**CITY COUNCIL AGENDA ITEM  
CITY OF SHORELINE, WASHINGTON**

<b>AGENDA TITLE:</b>	Adoption of Ordinance No. 361, a preliminary formal subdivision for 32 zero lot line lots located at 19201 15th Avenue NE
<b>DEPARTMENT:</b>	Planning and Development Services
<b>PRESENTED BY:</b>	Timothy M. Stewart AICP, PADS Director Paul MacCready, Planner

**CEDAR HEIGHTS - PRELIMINARY PLAT**  
19021 - 15th Avenue Northeast  
Shoreline, Washington

<p><b>AGENDA TITLE:</b> Cedar Heights Preliminary Formal Subdivision <b>DEPARTMENT:</b> Planning and Development Services <b>PRESENTED BY:</b> Paul E. MacCready, Planner</p>
---

**ATTACHMENT B**  
CEDAR HEIGHTS - PRELIMINARY PLAT  
PLOT PLAN

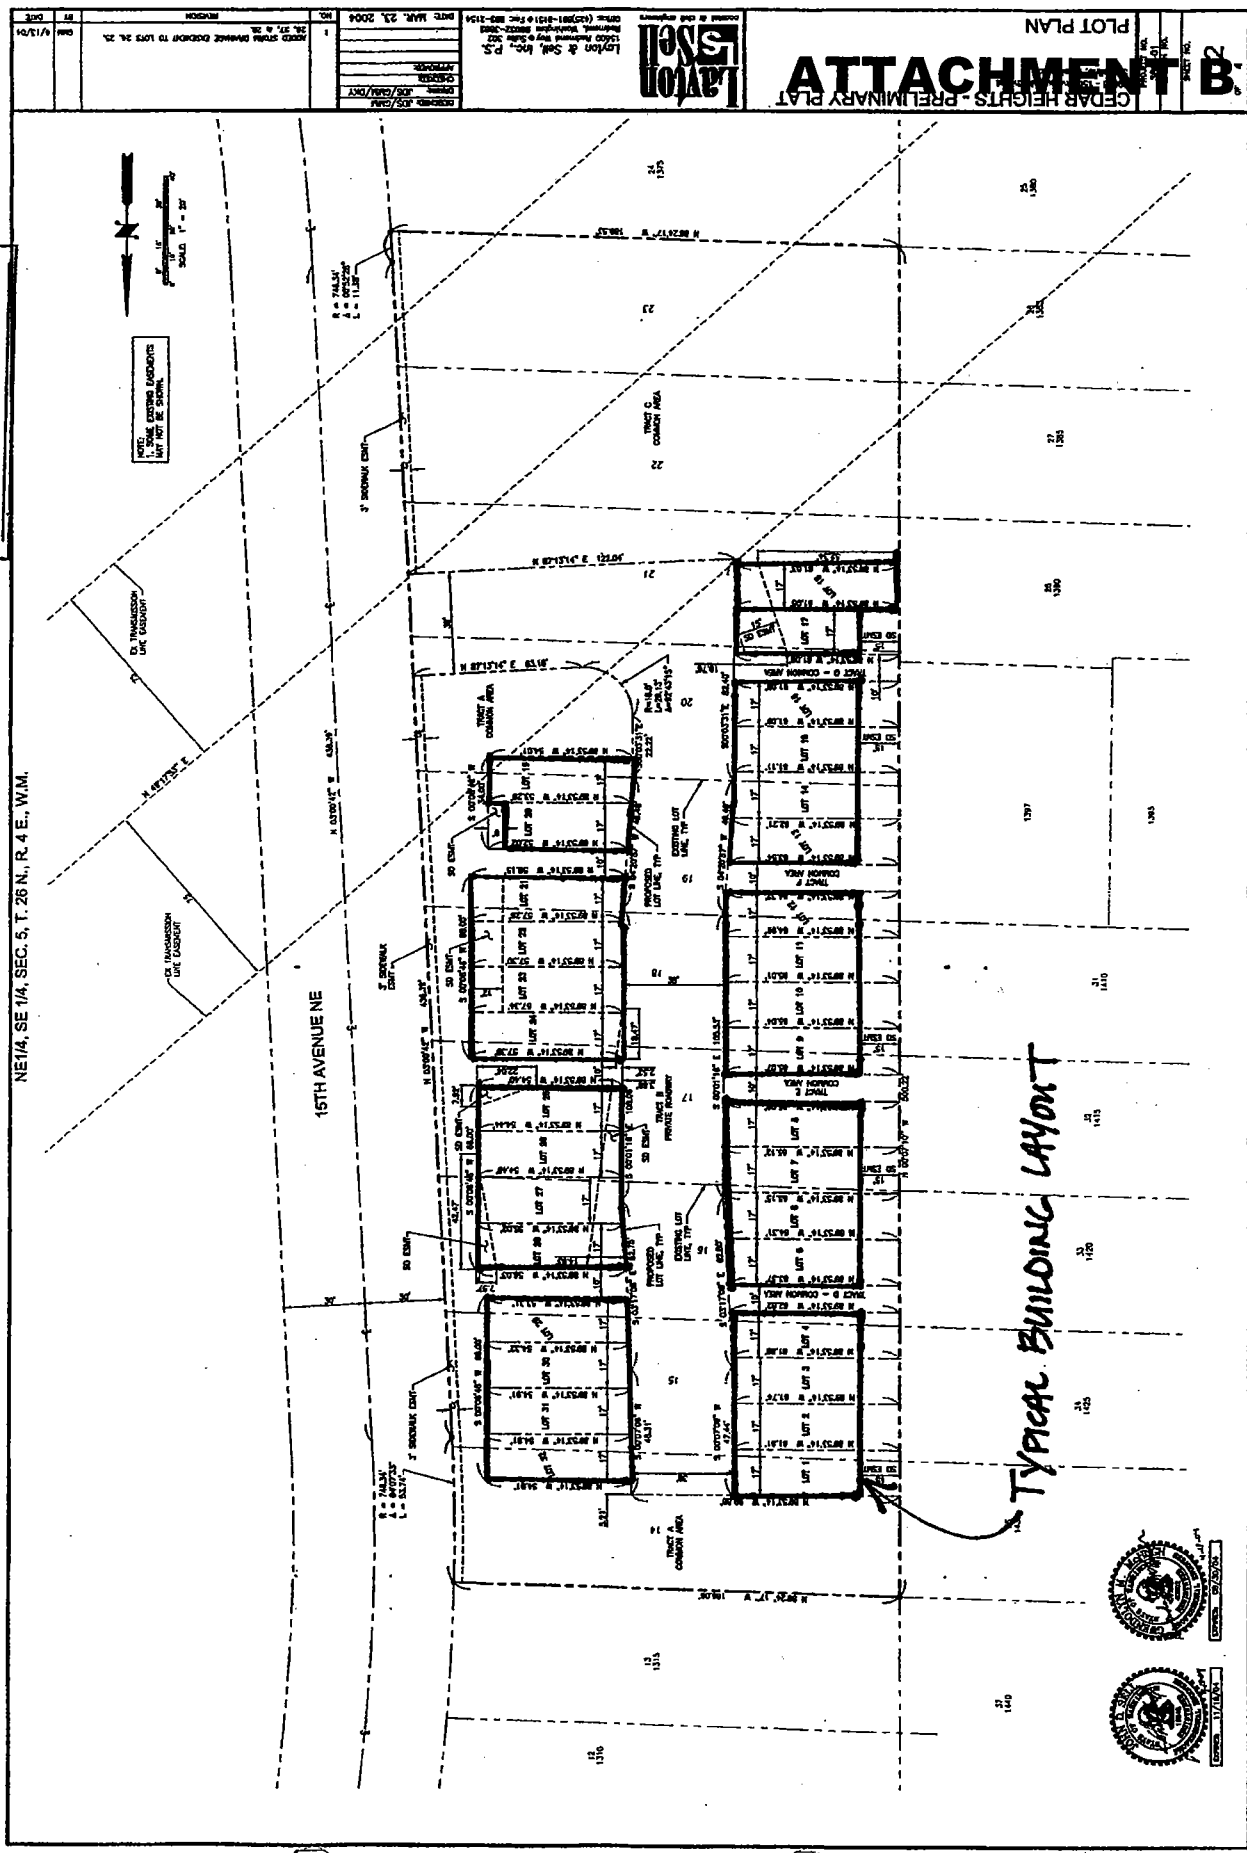
Commissioner Kuboi referred to Condition 9 of the Staff Report, which makes reference to no part of the building lot being allowed to encroach into the utility easement. However, he noted that in Attachment B it appears that one of the units is encroaching. Mr. MacCready said this would have to be revised for final plat approval. Mr. Graves clarified that the property lines have been moved to be parallel to and on the right-of-way line. The building would not be in the right-of-way. While the property line is currently in the right-of-way, this would be adjusted. Commissioner Phisuthikul referred to Attachment I, which shows the lot line encroaching into the right-of-way, but not the building line. Mr. Graves again stated that this would be corrected before final plat approval.
